CITY OF PORTLAND, MAINE
HISTORIC PRESERVATION BOARD

HISTORIC PRESERVATION BOARD AGENDA

**WORKSHOP
62 INDIA STREET**

RE: April 20, 2016 **Workshop (2nd)** – Preliminary Review of Proposed New Construction

PROPOSED ROOF PLAN - REVISED OPTION ONE

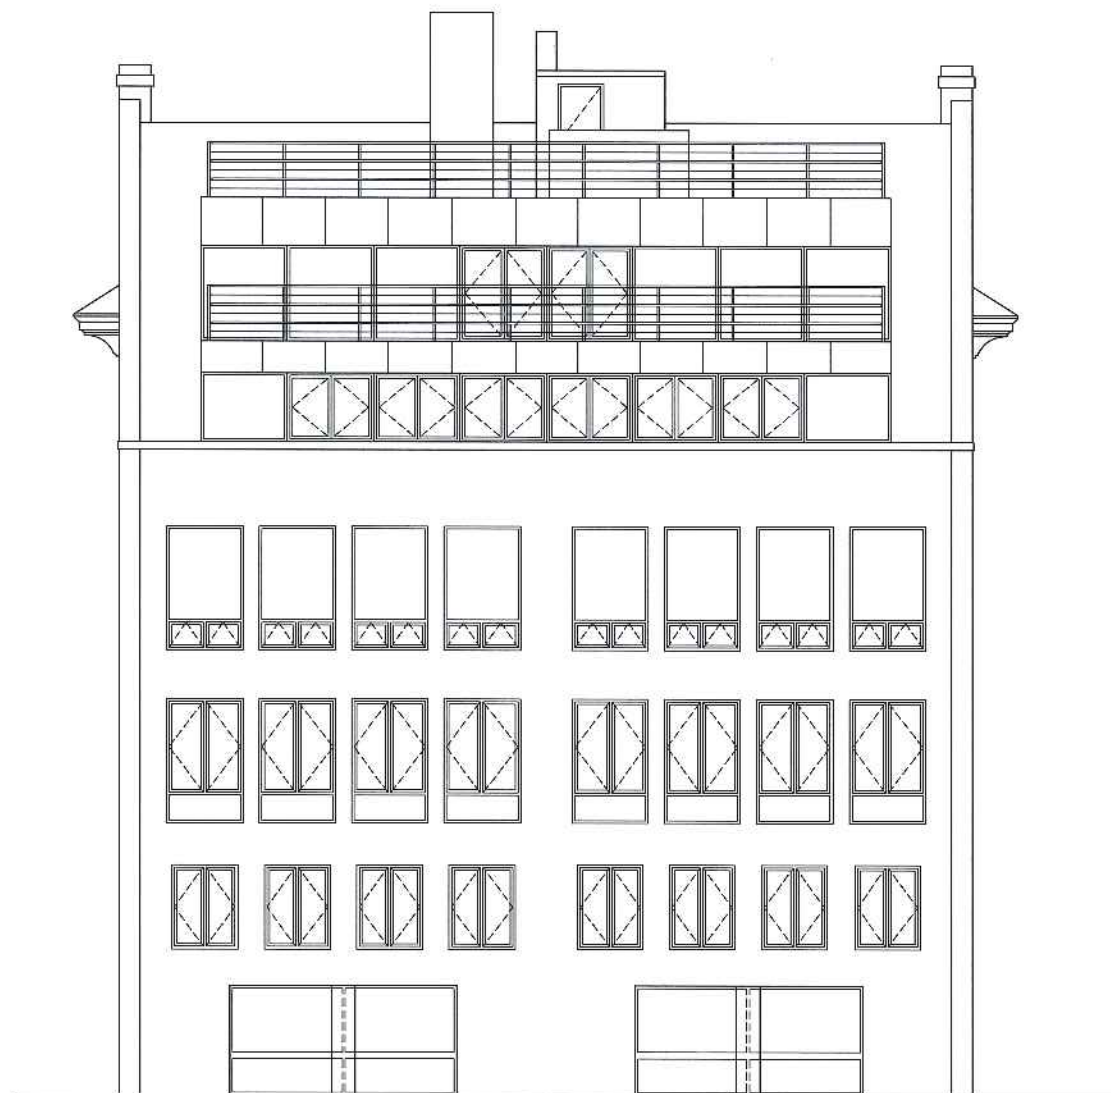
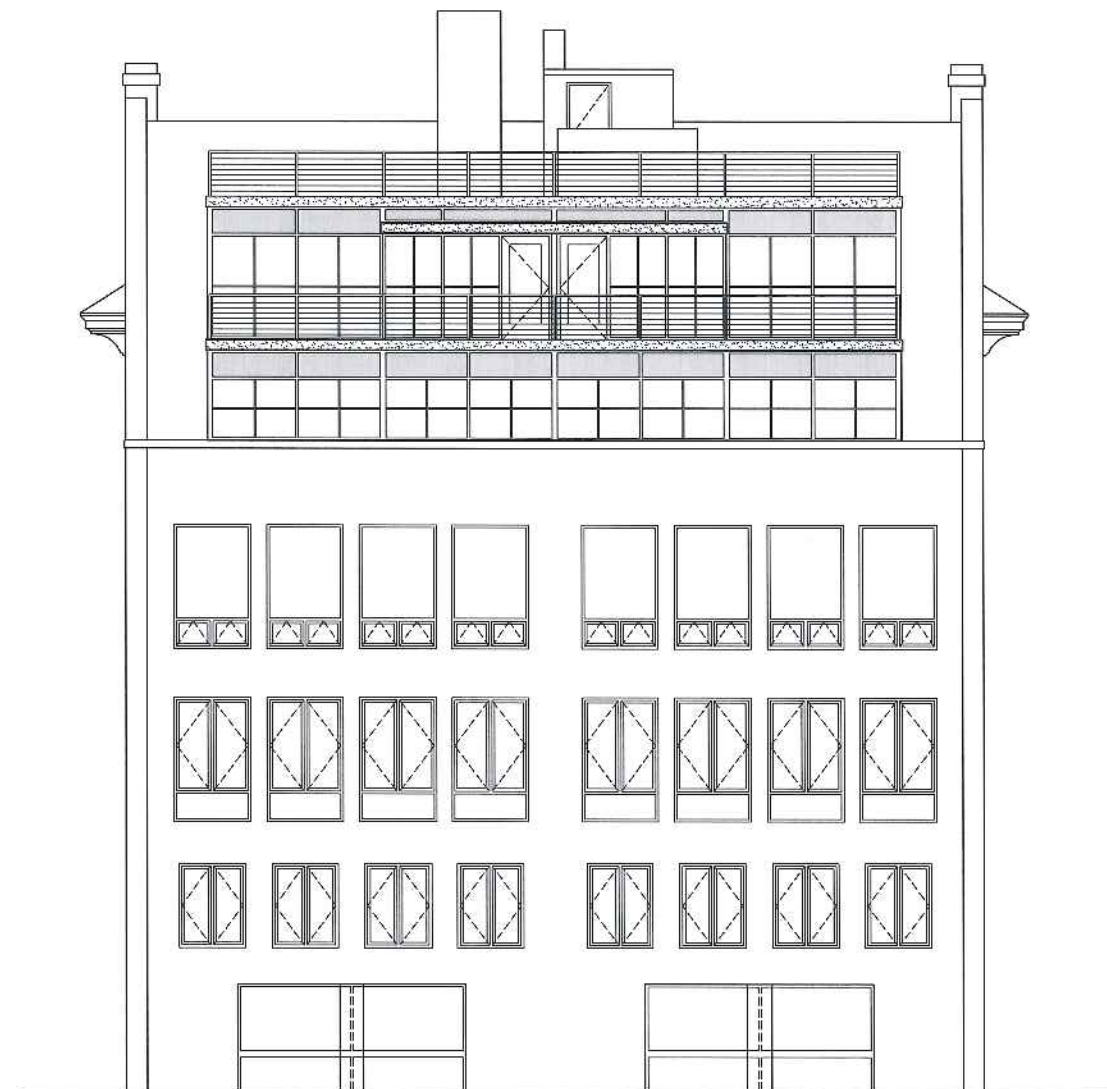
The comments made by the Board at the March 2nd workshop cast doubt on the likelihood that any sixth floor loft addition would receive approval. Despite the incorporation of existing rooftop clutter and the resulting simplification of the profile at the top of the structure, the increased mass and height are problematic. The current proposed loft in revised Option One incorporates a step by having a smaller footprint - which improves the design - but the perspectives provided show a persistent danger that the addition will create an awkward distraction from the original roofline.

Carroll Block - Portland, Maine
Elevations - Phase 3

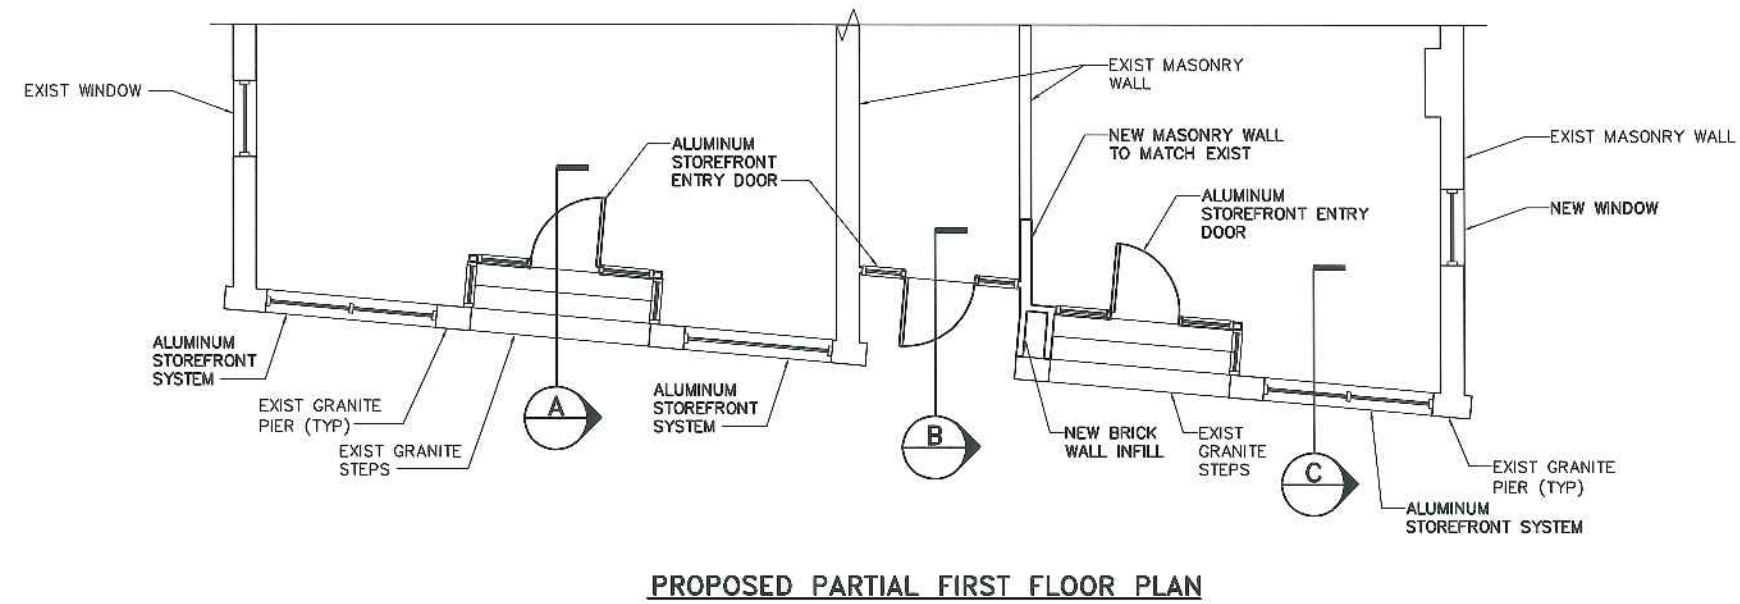
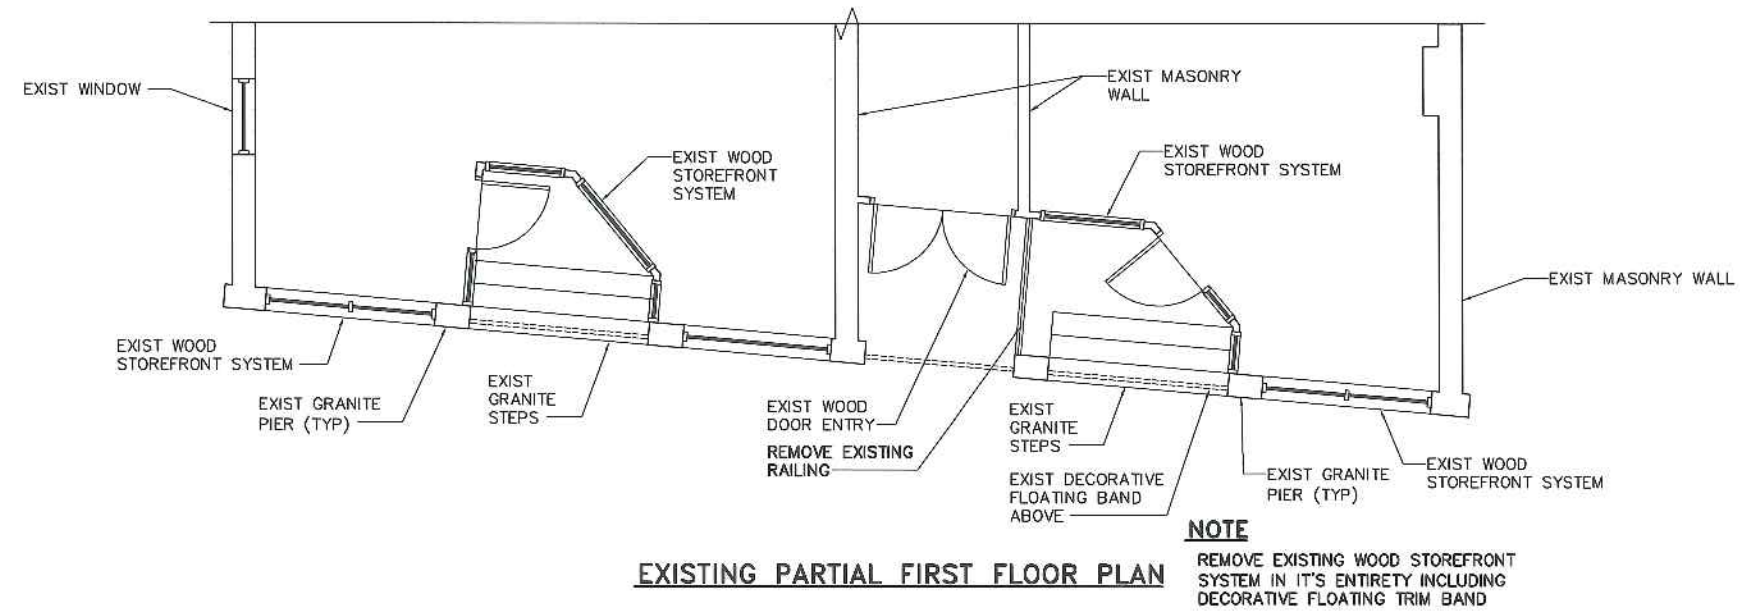
It is difficult to distinguish details from the 1924 tax photo of the building, but the proposed improvements to the storefronts appear to create a configuration that is closer to the old layout. Proposed plans show new aluminum inswing doors for the stores on either side, opening directly toward the stairs and street, and the lobby entrance near the middle would be brought forward, closer to the sidewalk. Sections show the transom windows all in the same plane, close to the front of the massive granite piers, and overall, a more regular and vertical pattern for the storefront fenestration.

- The plane of the transoms, relative to the doors, and to the storefront windows
- The benefit of all the doors facing the street, with elimination of landings
- The use of aluminum storefront components, and possible color choices
